JZ24-32 FELDMAN KIA PRO

FELDMAN KIA OF NOVI
40575 GRAND RIVER AVENUE
PRELIMINARY SITE PLAN
CITY OF NOVI, OAKLAND COUNTY

PLANNING REVIEW

Rezoning Request from NCC (Non-Center Commercial District) to B-3 (General Business) with Planned Rezoning Overlay (PRO)

CAR HAULER TURNING
1" = 30'

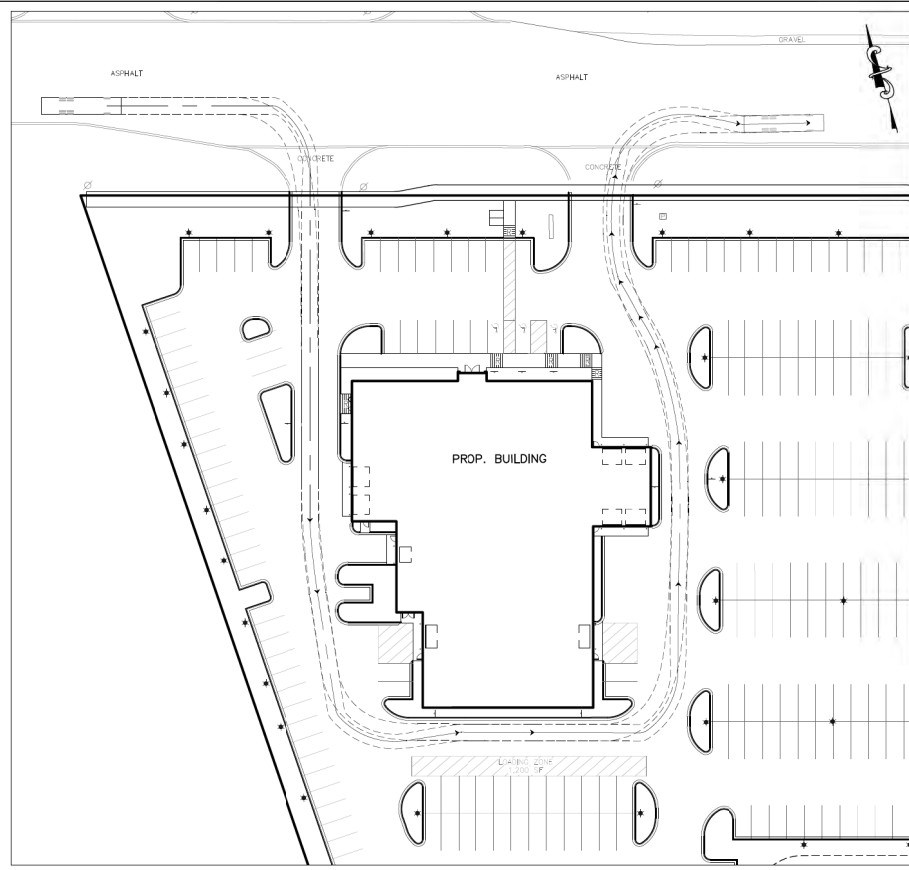
lot so that there is a clear path around the dealership to the rear parking lot with sufficient room for car hauler turning radius. See Site Plan sheet number 8 and below:

L-3

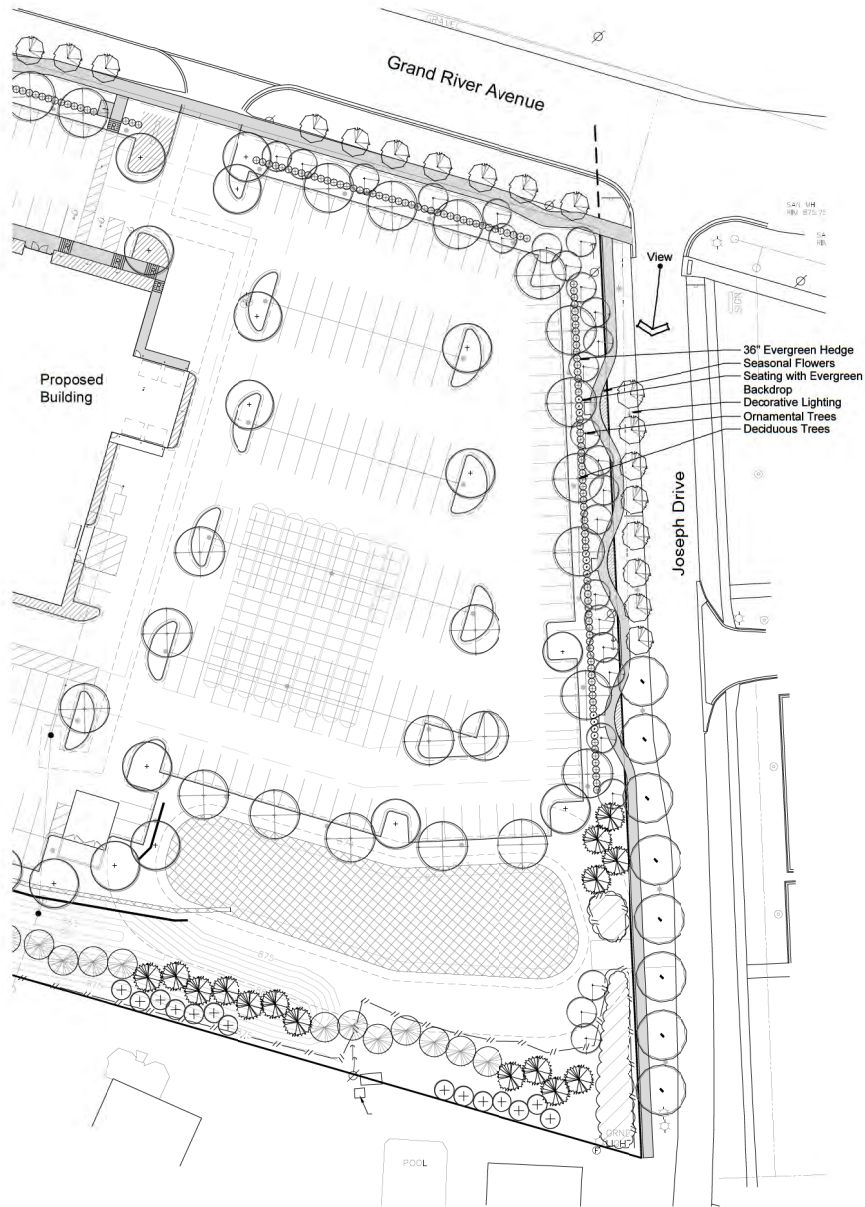
Staff Comment: Sheet L-4 of the PRO Plan shows a total of 3 benches to be provided at intervals along the sidewalk, and includes a detail of the proposed benches and decorative lighting fixtures. The benches and decorative lighting can be considered an enhancement. Providing a sidewalk on the Joseph Drive frontage is a requirement, so the meandering nature of it is the only unique feature, which may or not be considered an “enhancement.”

ARCHITECTURAL SITE
PLAN - PRO SIGNAGE

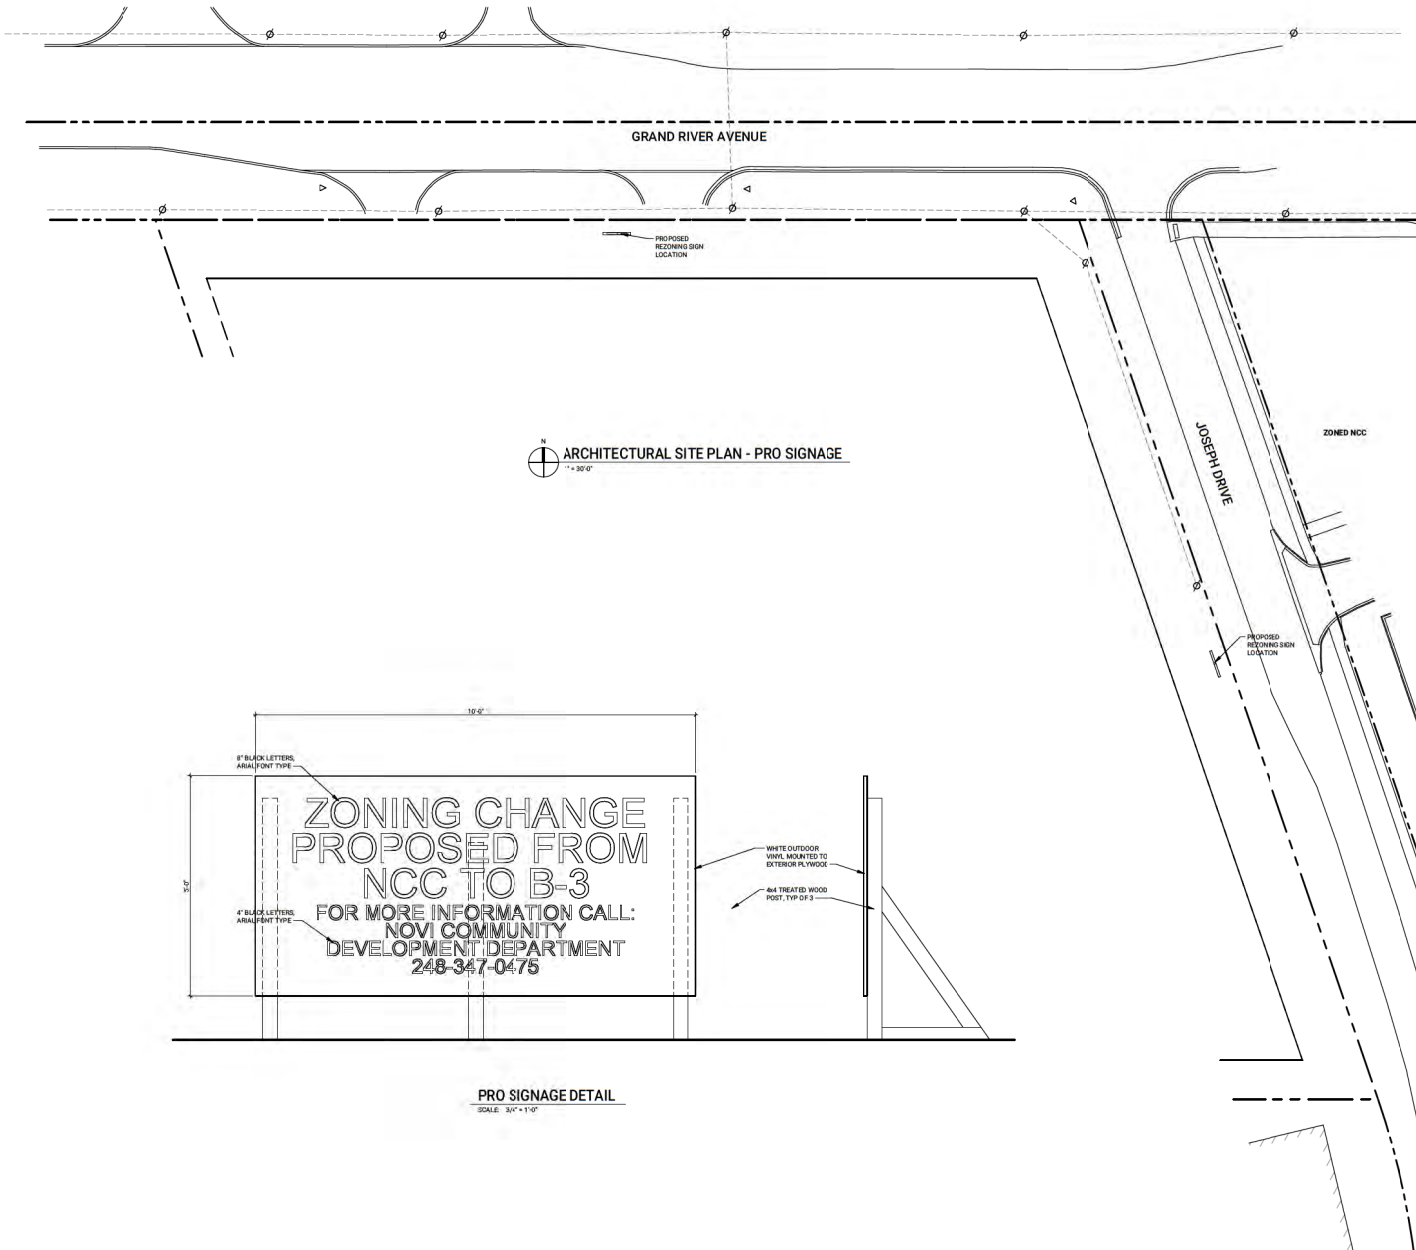
- d. Sign Location Plan: A rezoning sign location plan and sign detail has been provided on Sheet SP1.3. The sign locations and wording are acceptable, and were posted prior to the previous public hearing.
